Memorandum

To: Mike Geisel, City Administrator
From: Tom McCarthy
Date: 10/19/2021
Re: Central Park Eight Acre Conceptual Master Plan

Central Park Master Plan

Final Master Plan Report

CONCEPT ALTERNATIVES COMMUNITY FEEDBACK

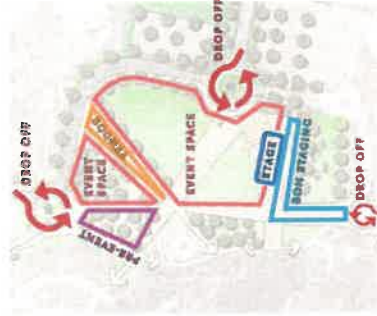
Community was asked to identify their preferences, likes, and dislikes of each concept via an online survey. 50 people participated over approximately two weeks from March 18th to March 31st. Overall the community members who respond to the online survey preferred Concept C. (the numbers below each concept above is an aggregate score based on a number one preference ranking receiving three points, number two priority receiving two points and number three priority receiving one point.)

CONCEPT A - COMMUNITY FEEDBACK SUMMARY

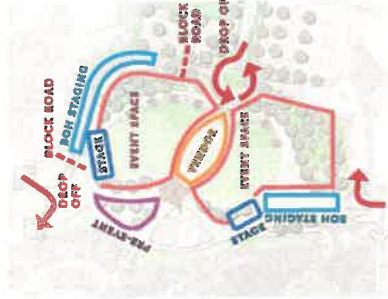
- Removal of Veteran's Place Dr. thru the Park
- Incorporation of Awakening into the Park
- Green space and separate lawns for use
- Large walkways / paved areas for events
- Incorporation of shade trees

- Design too angular/geometric/rigid
- More green space should be included/minimize paving
- Would like to see inclusion of shade/pavilion structure
- Additional parking is needed
- Should include location for more than one stage
- Should include feature for use outside festivals / community events
- Concerned closing road will limit access to center of park

CONCEPT B - COMMUNITY FEEDBACK SUMMARY

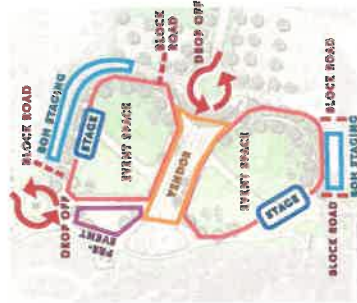
- Like the removal of Veteran's Place Dr. thru the Park
- Like the organization and flexibility of spaces, aesthetically pleasing design, balanced hardscape and softscape areas
- Like the iconic pavilion, terraced seating and shade structures
- Like the option for multiple events

- More green space should be included/ minimize paving
- Additional parking is needed
- Awakening feels separated from the park
- Concerned closing road will limit access to center of park
- Consider including park features not geared toward festival use
